# Objection Letter

Relating to Planning Application PT17/5810/RM, Erection of 763 dwellings, community building, nursery and retail units with parking, landscaping and associated works. (Approval of reserved matters to be read in conjunction with outline planning permission PT06/1001/O). | Land At Harry Stoke Harry Stoke Road Stoke Gifford Bristol South Gloucestershire BS34 8QQ

Robert Forsey, The Willows, Harry Stoke Road  
4<sup>th</sup> March 2019

Side view of proposed development in the field directly opposite Harry Stoke Road

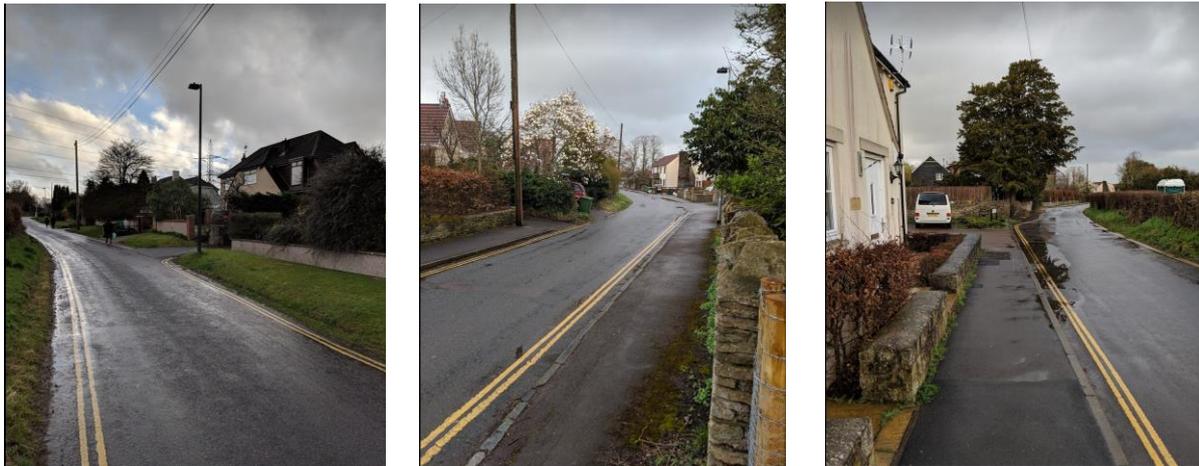
The current plan does not manage the impact of urban intensification by having a large block of continuous apartments, it is also arguable that massing the apartments and small terraced houses together will not lead to safe and inclusive communities. Creating a more diverse mix of properties as originally proposed would be more aligned with these policies.
